Lot: 118

Model: 40.02 A VALLEYVIEW

Project/Phase: Pine Valley Forevergreen / 1

PURCHASER'S ESTIMATE REQUEST
Pine Valley Forevergreen - Phase 1
PURCHASER: Inventory Product TEL:
LOT NUMBER 118 PHASE 1 HOUSE TYPE 40.02 A VALLEYVIEW
EXTRA CHARGE
1 2 - BASEMENT WINDOWS - UPGRADE BASEMENT WINDOW SIZE TO 30 " X 24" - 8" FRAME \$ 420.00
2 1 - BACK-FLOW PREVENTER VALVE \$ 675.00
\$1,095.00 Sub Total
\$142.35 HST
\$1,237.35 Total

BASEMENT | ELEV. A
E

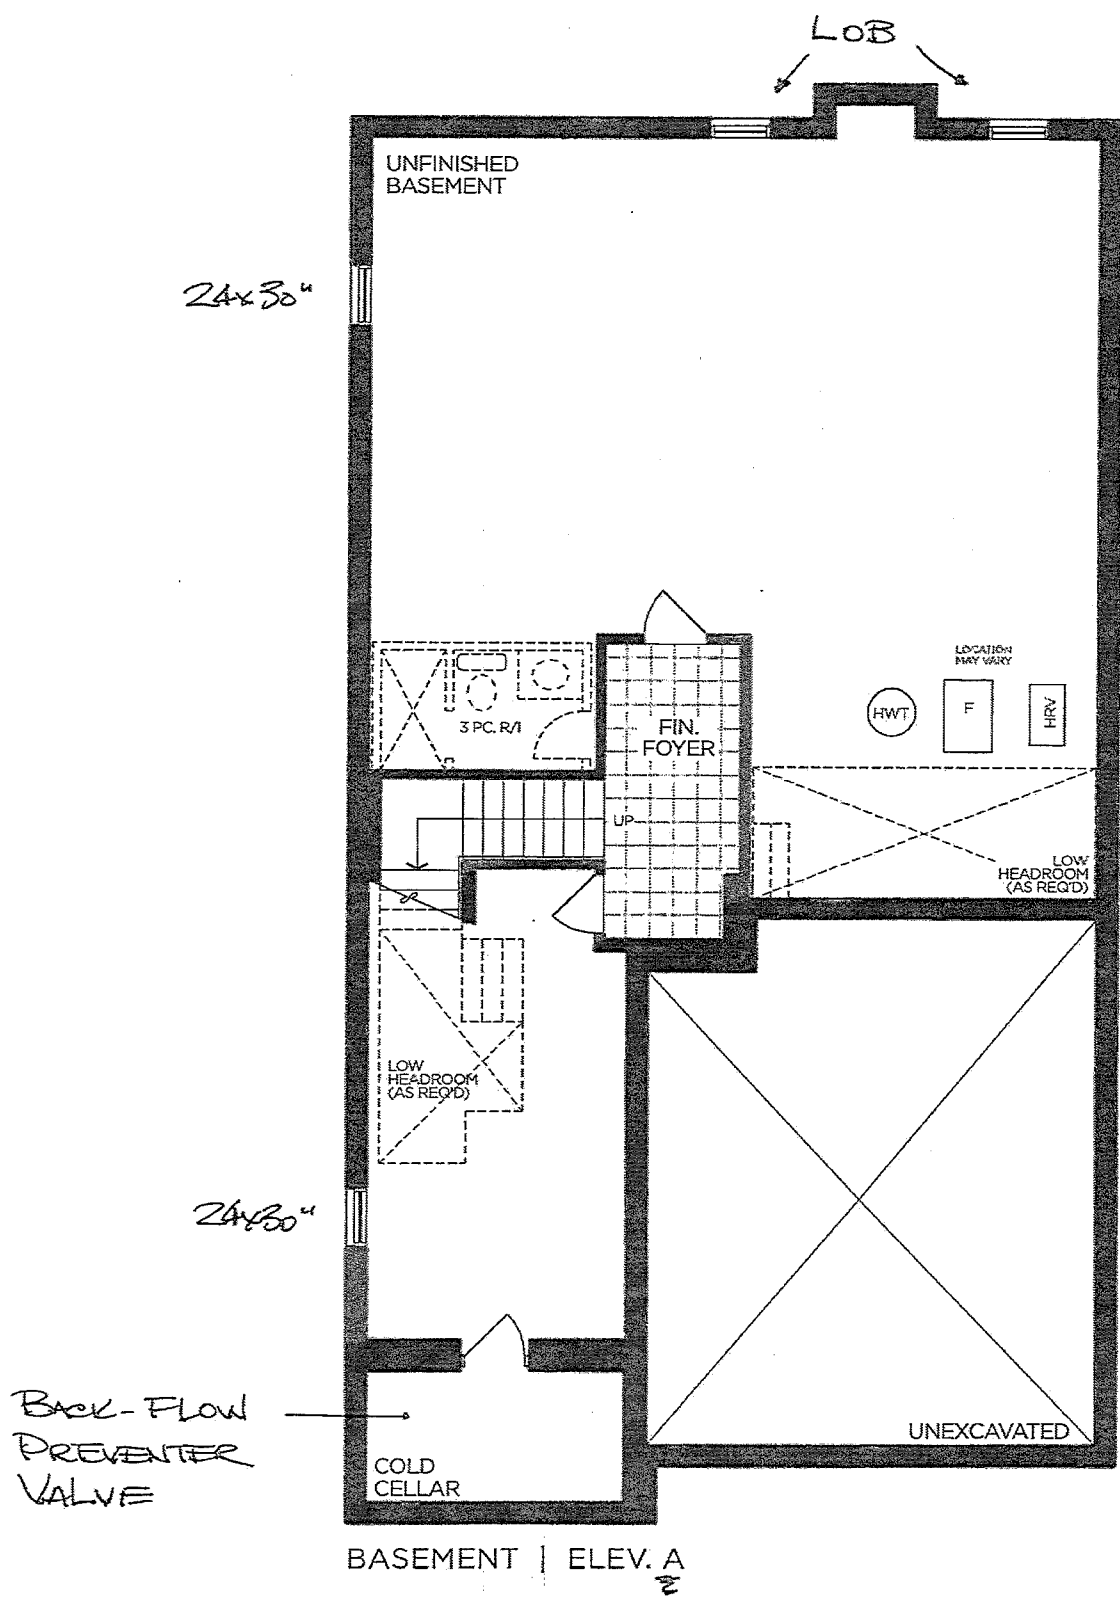
Invoice	Qty.	Description
2258 31986 31Mar20 NoCat	1	BACK-FLOW PREVENTER VALVE CONCRETE AND DRAIN

Invoice	Qty.	Description
2258 31959 31Mar20	2	BASEMENT WINDOWS - UPGRADE BASEMENT WINDOW SIZE TO 30 " X 24" - 8" FRAME WINDOWS - BASEMENT 72,351 WINDOWS - BASEMENT
